# Access Compliance Report

## Public Rights-of-Way

### (Curb Ramps)

Intersection ID: 10725	Main Street: N_TRYON_ST	Cross Street: KESWICK_AV	Location: N
ADA ID: 22B563F0D60D	Ramp Type: PerpDiag	Initial Pass/Fail: Fail	Overall Compliance: No
		Severity Score: 10

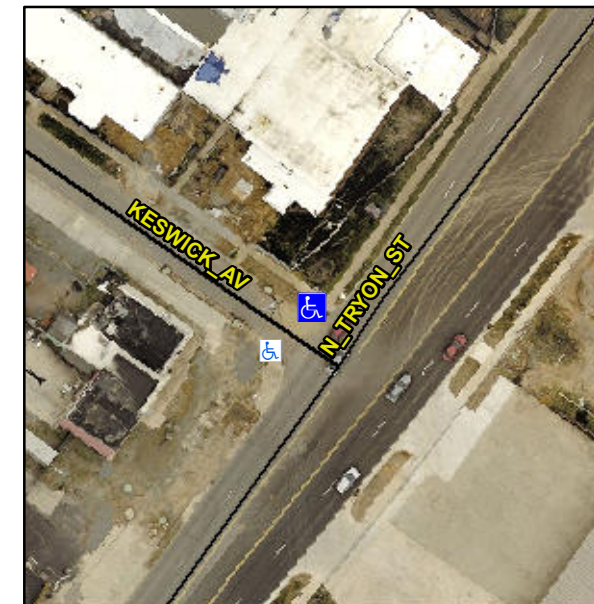
**Not Found, R304.5.1, R304.5.3**

Compliance	Description	Data	Compliance	Description	Data
N/A	Ramp Length (in)	40.0	Yes	Ramp Slope (%)	6.9
No	Ramp Width (in)	40.0	No	Ramp XSlope (%)	2.4
N/A	Flare Type LT	N/A	N/A	Flare Type RT	N/A
N/A	Flare Slope LT (%)	N/A	N/A	Flare Slope RT (%)	N/A
N/A	Flare Traversable LT?	N/A	N/A	Flare Traversable RT?	N/A
N/A	Landing Length (in)	N/A	N/A	DWS Provided?	N/A
N/A	Landing Width (in)	N/A	N/A	DWS Contrast?	N/A
N/A	Landing Slope (%)	N/A	N/A	DWS Length (in)	N/A
N/A	Landing X Slope (%)	N/A	N/A	DWS Full Width?	N/A
N/A	Landing Curb? (Y/N)	N/A	N/A	DWS Offset (in)	N/A
N/A	Shared Landing?	N/A			
N/A	Gutter Ponding?	N/A	N/A	Gutter Slope (%)	N/A
N/A	Gutter Lip Ht (in)	N/A	N/A	Gutter X Slope (%)	N/A
N/A	Painted X Walk1?	No	N/A	Painted X Walk2?	No
	X Walk 1 Direction	To SW		X Walk 2 Direction	To SE
N/A	X Walk 1 Width (in)	N/A	N/A	X Walk 2 Width (in)	N/A
	X Walk 1 Slope (%)	3.9		X Walk 2 Slope (%)	3.1
	X Walk 1 X Slope (%)	0.4		X Walk 2 X Slope (%)	4.5

**Remove & Replace Curb Ramp With Two New Directional Ramps or Equivalent.**
